FST2XT Software

Change History

Release: FST V0174, 13.01.2023

8) Hydraulic Rail Clamping:

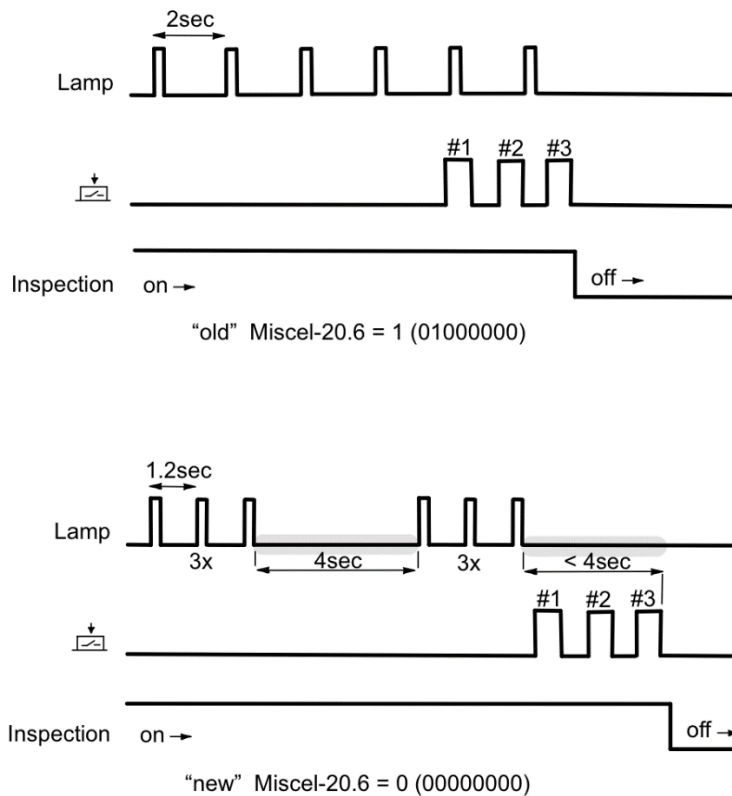
for the automatic lift-rope tensioning mode (FST V0173), the maximum (fixed) operating wait time has been extended from 3 to 8 seconds.

2) Inspection end-switch Monitoring: New function added for Shaft-Top or Bottom switches. The function is set to operate by using one or two of the new input I/O Port:

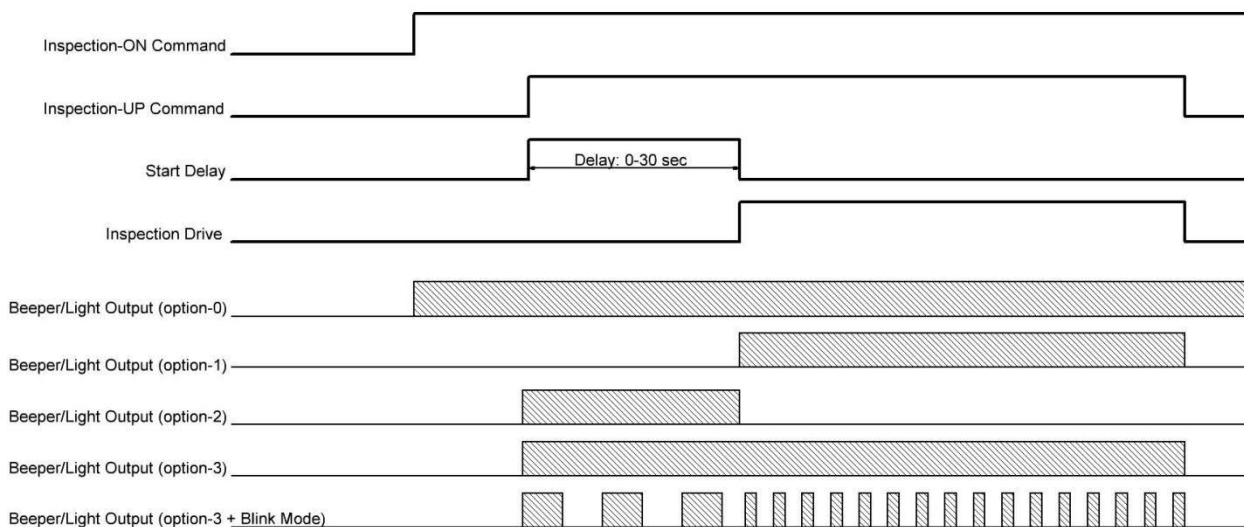
Menu: Port RAW = 0000 0000 0000 000T 0100 0010 1111 001x

T=0 tests input for activation in Bottom floor

T=1 tests input for activation in Top floor
